UNITED STATES PATENT AND TRADEMARK OFFICE

Office Action Summary	Application No. 10/811,055	Applicant(s) CLINE, JOHN B.	
	Examiner Ginger T. Chapman	Art Unit 3761

DETAILED ACTION

FIG. 2

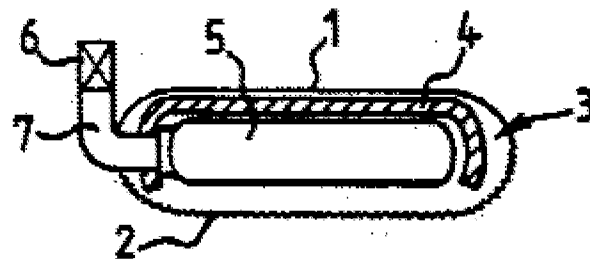
Regarding claims 35, 59 and 60, Kawasaki teaches a device (1) capable of sealing a stoma to control the passage of liquid and solid waste material through the stoma, said device (1) being situated entirely externally to the body and comprising recess defining means (4);

adhesive (14, 15) surrounding and enclosing a stoma capable of securing said recess defining means (4) to the body such that the recess defining means forms a seal with the body completely surrounding and enclosing the stoma (A);

and stoma covering means (5), situated externally to the body, over the stoma (A), within said recess defining means (4), and comprising a continuous, uninterrupted member adapted to prevent passage of liquid and solid waste material through the stoma (A) when pressed against the stoma (A), said recess defining means (4) defining, with said stoma covering means (5), a chamber, said chamber comprising a fluid entrance port (7) and being situated over said stoma covering means (5), said chamber being pressurizable with fluid through said fluid entrance port (7) to press said stoma covering means (5) against the stoma and further comprising means for sealing (6) said fluid entrance port to prevent the fluid from escaping said chamber after it is pressurized (col. 7, lines 10-15; col. 9, lines 20-33)(see figures 2 & 4, *infra*).

FIG. 4

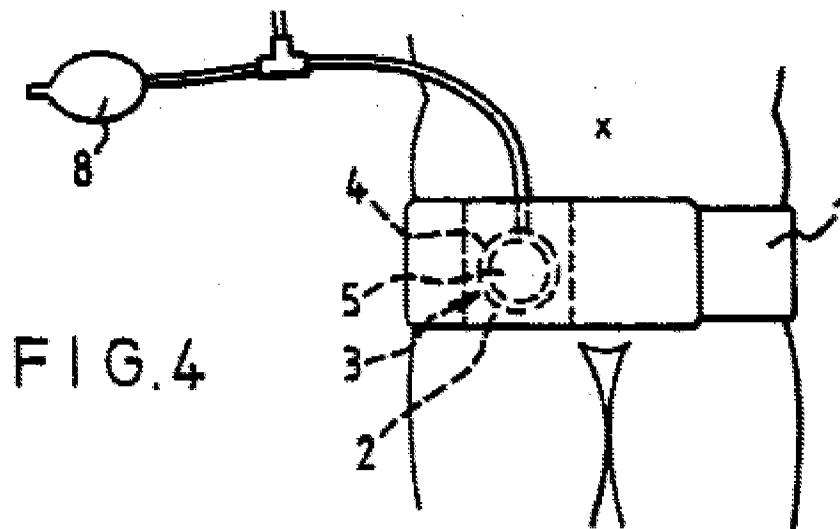
Kawaski discloses the claimed invention except for the adhesive completely surrounds and encloses the stoma. Kawaski provides motivation for a seal. As best depicted in Figures 2, 3, 5-12, Wagner teaches providing seal completely surrounding and enclosing a stoma on all sides. Therefore it would have been obvious to one having ordinary skill in the art at the time the invention was made to modify the seal of Kawaski as taught by Wagner since Wagner states, at c. 4, ll. 29-31, that the benefit of this design is that it provides a gentle sealing force around the stoma which is sufficient to provide a seal against leakage but avoids stomach, i.e. skin irritation.

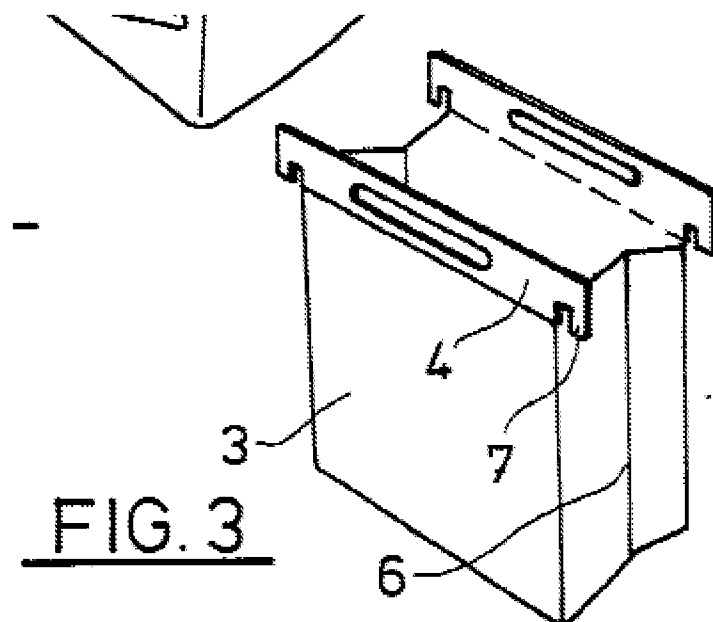
Bergmann teaches a waste bag (4) having a concertina configuration (see English language abstract)(see fig. 3, *infra*).

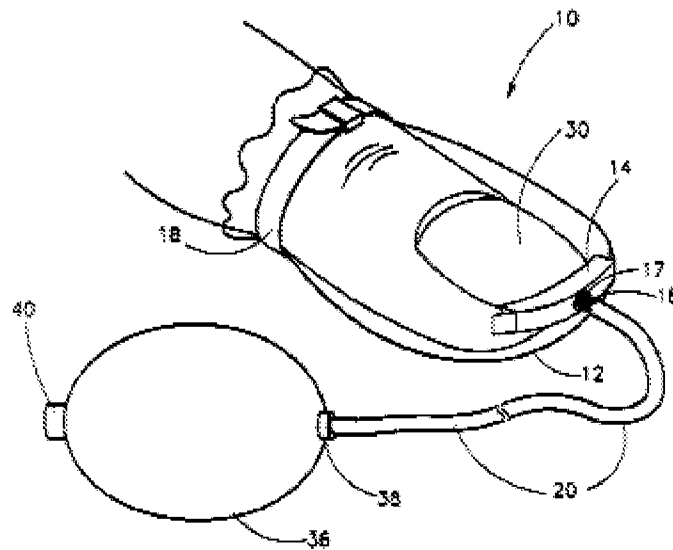
Berenstein teaches a pressure-limiting or relief valve or vent (22)(see fig. 1, *infra*).
